## Planning Commission Staff Report

**Meeting Date:** June 26, 2017

**From:** Jessica Henry, Senior Planner

**Petition:** **P.Z. 03-2017 Fienup Farms (McBride & Sons)**: A request for a zoning map amendment from an “E-1” Estate One-Acre District to a “PUD” Planned Unit Development for 223.02 acres located on the north side of Wild Horse Creek Road approximately 3,250 feet east of its intersection with Kehrs Mill Road and 4,400 feet west of its intersection with Baxter Road (18U640049, 18U630028, 18U330454, 17U310093, 17U320070, & 17T110201).

**Fienup Farms**  
Chesterfield, Missouri  
SITE DETAILS

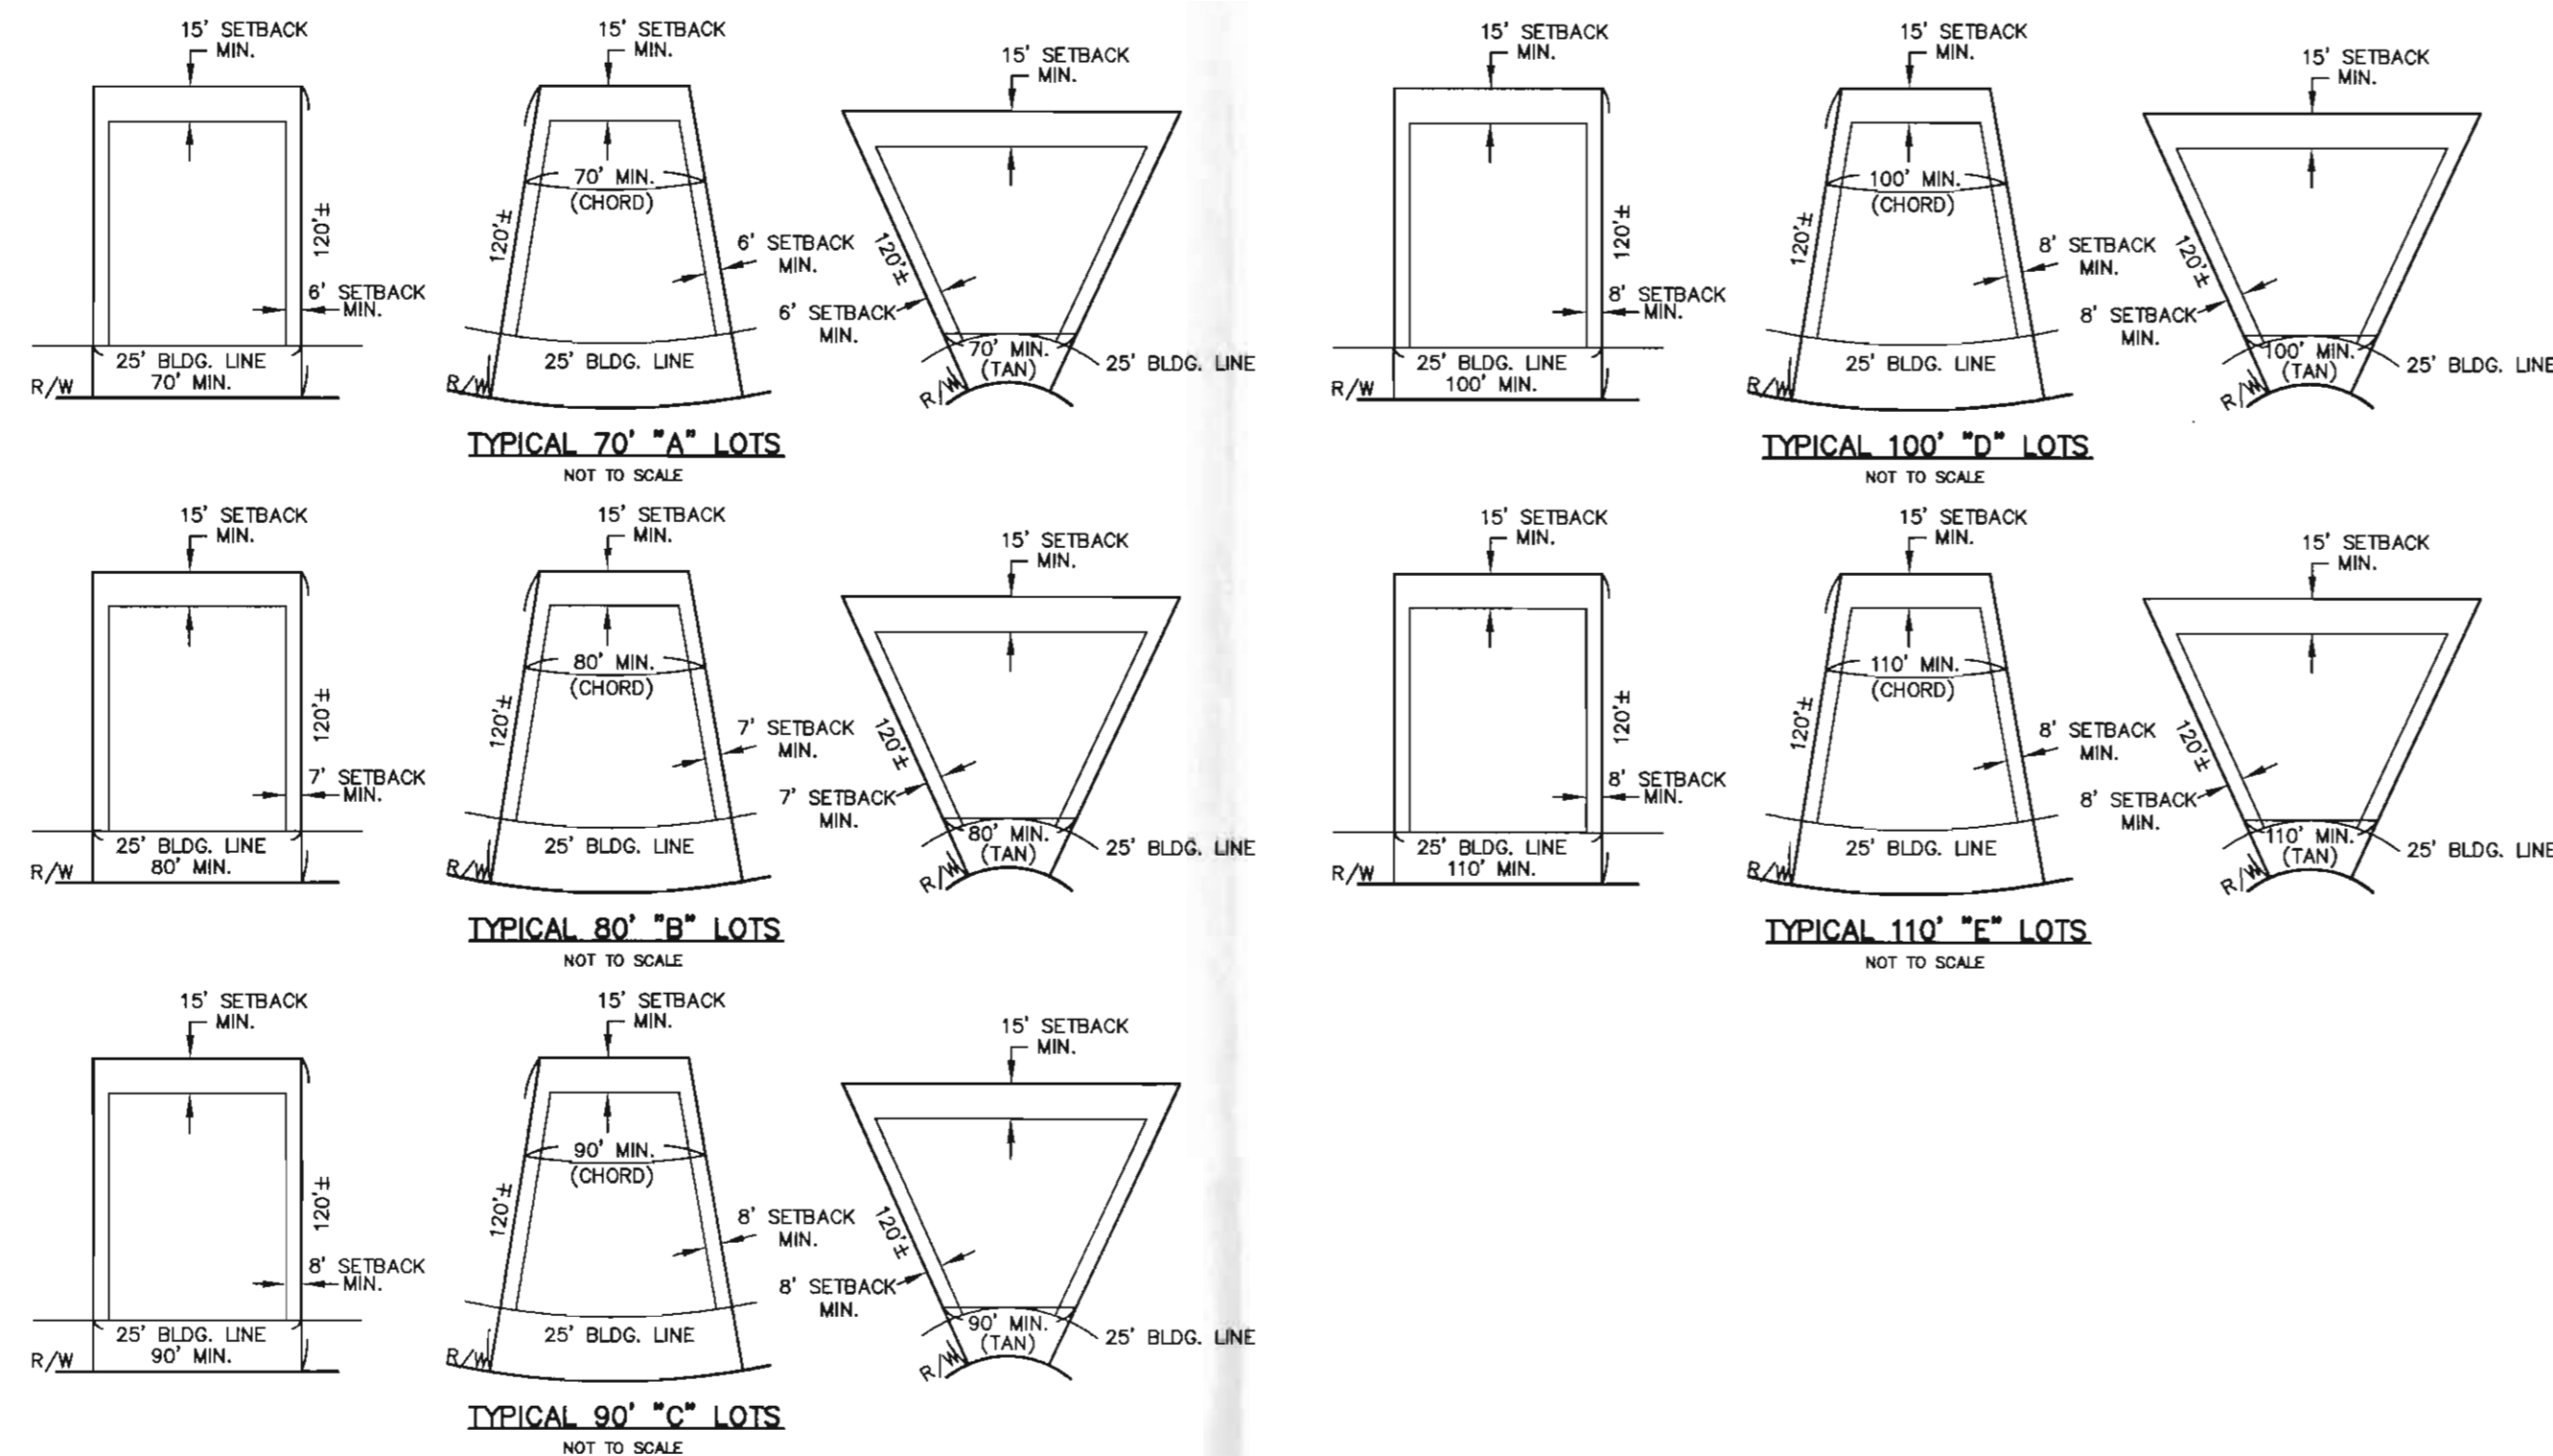
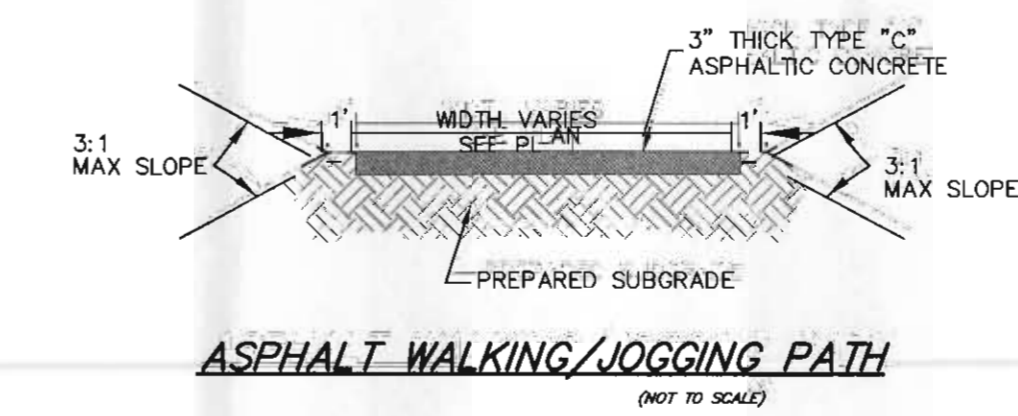
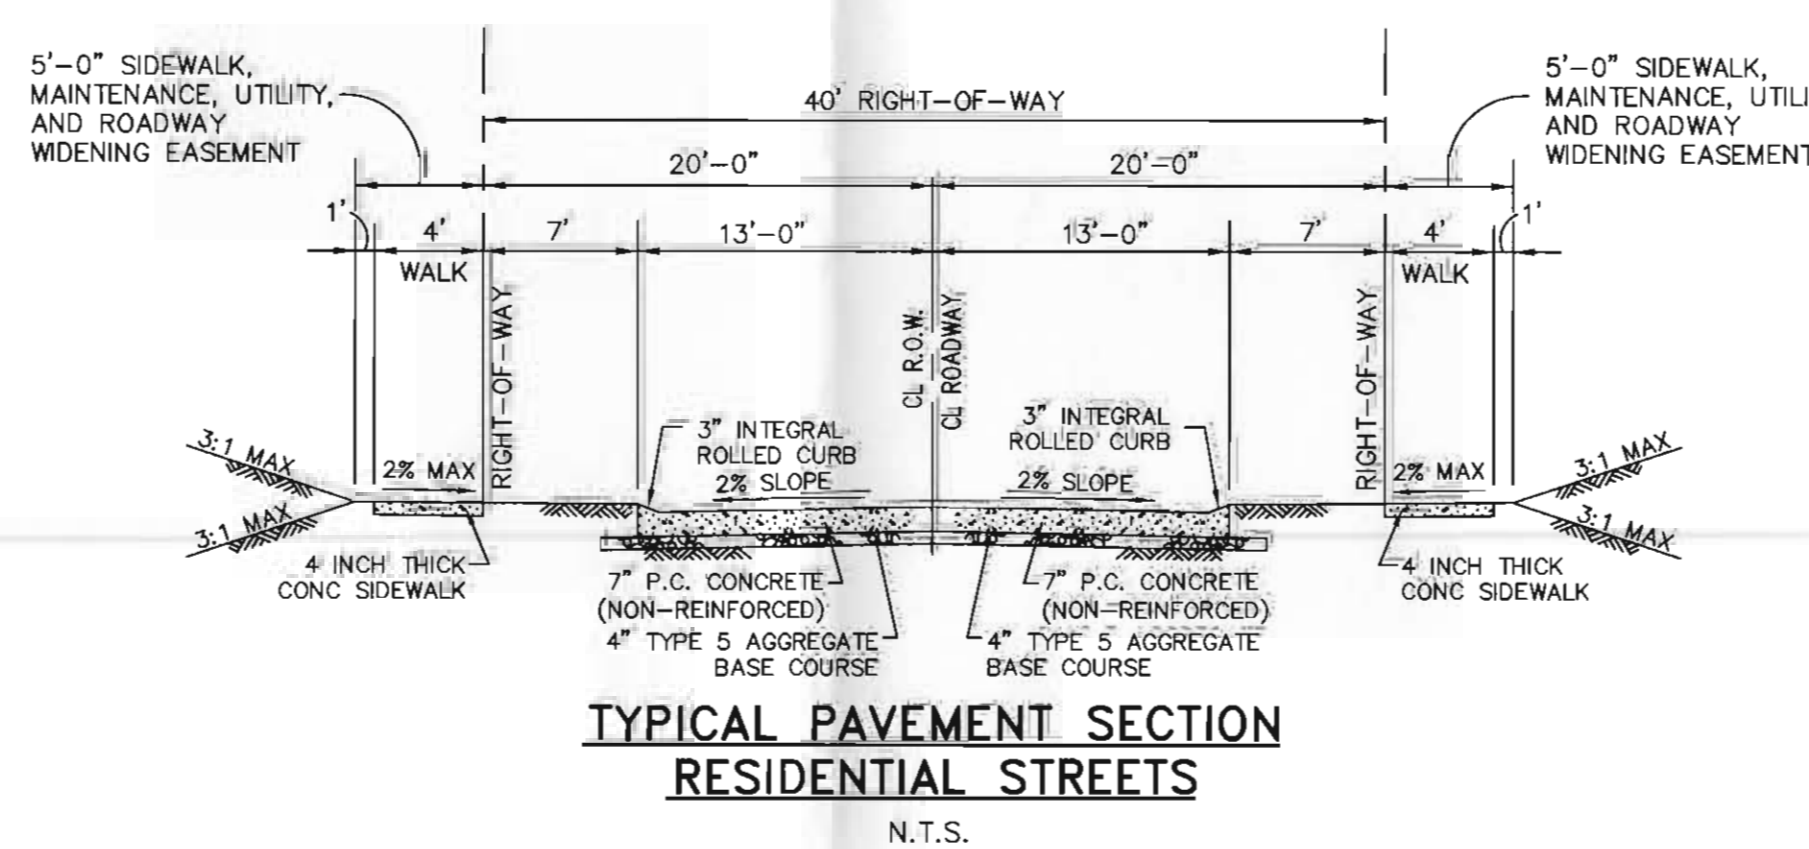
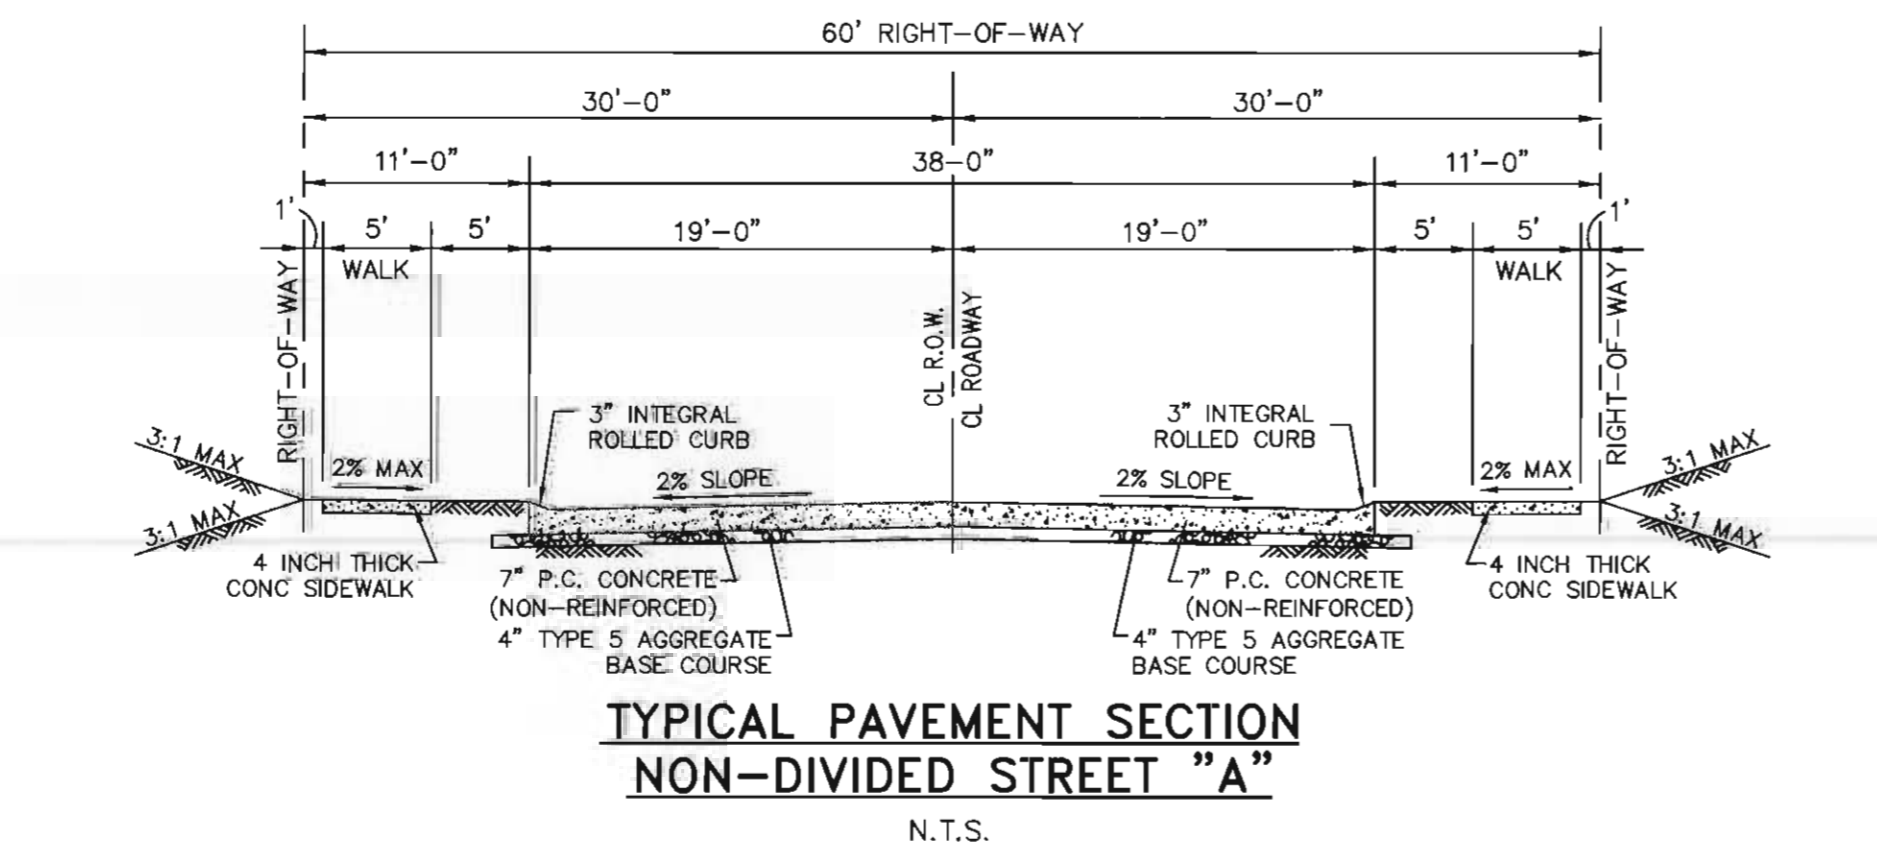
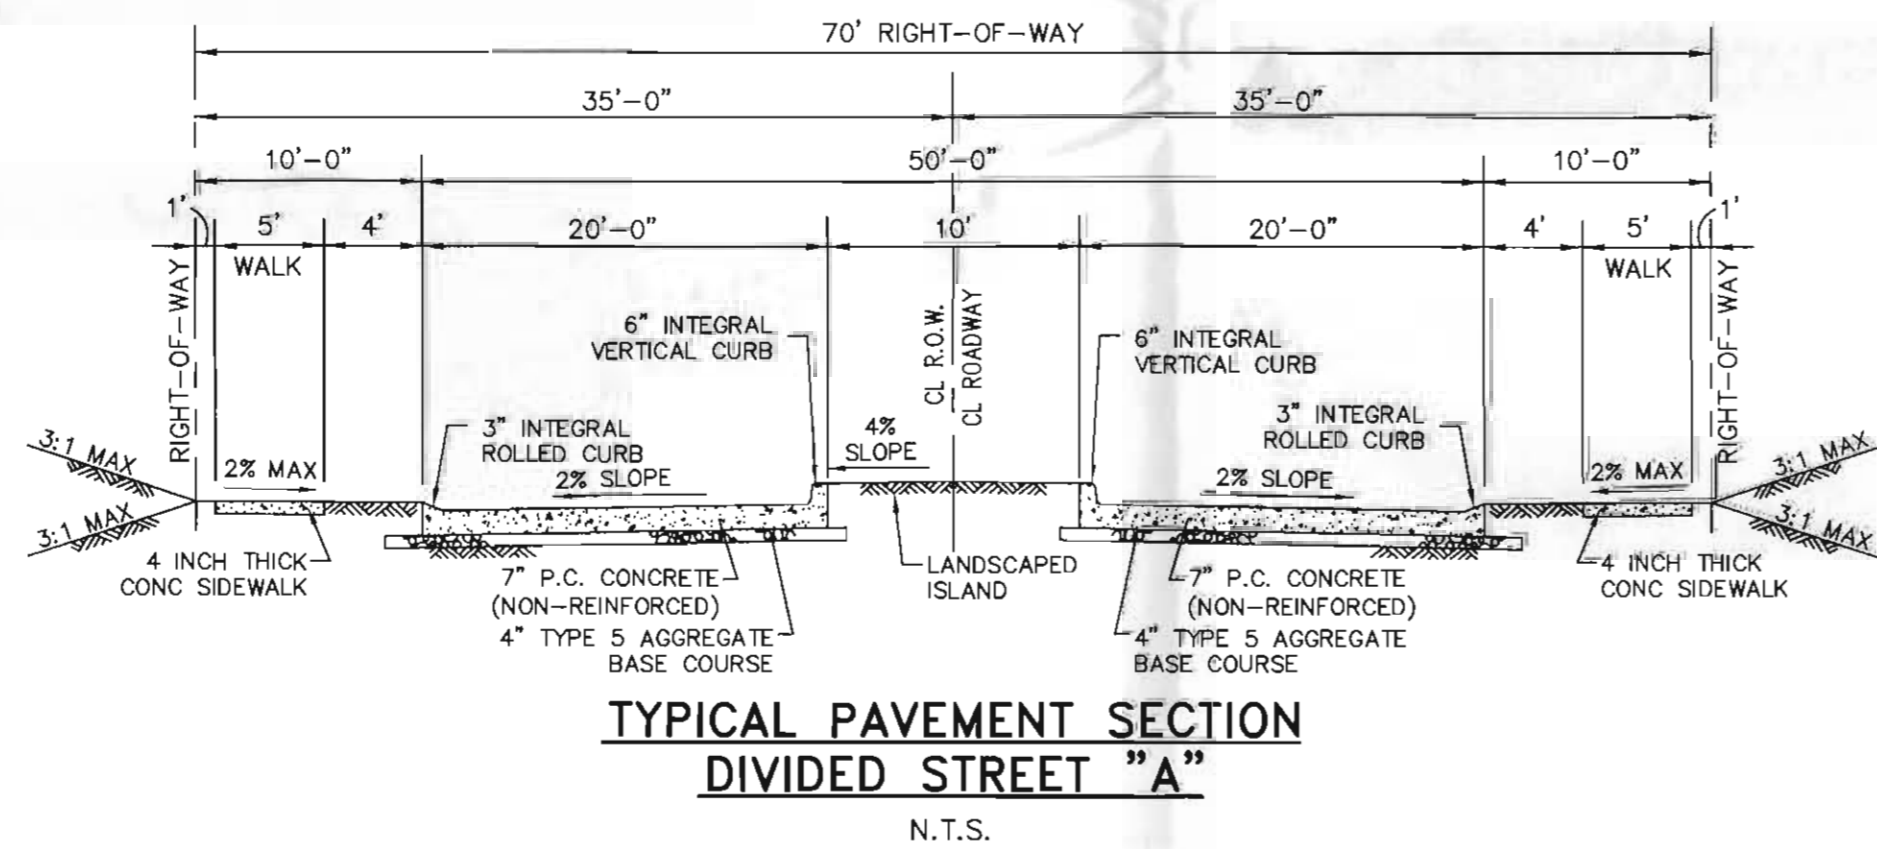
5. Pavement and Island Widths: A typical roadway section depicting the pavement and island width for “Street A” has been added to Preliminary Development Plan Sheet 1.2.
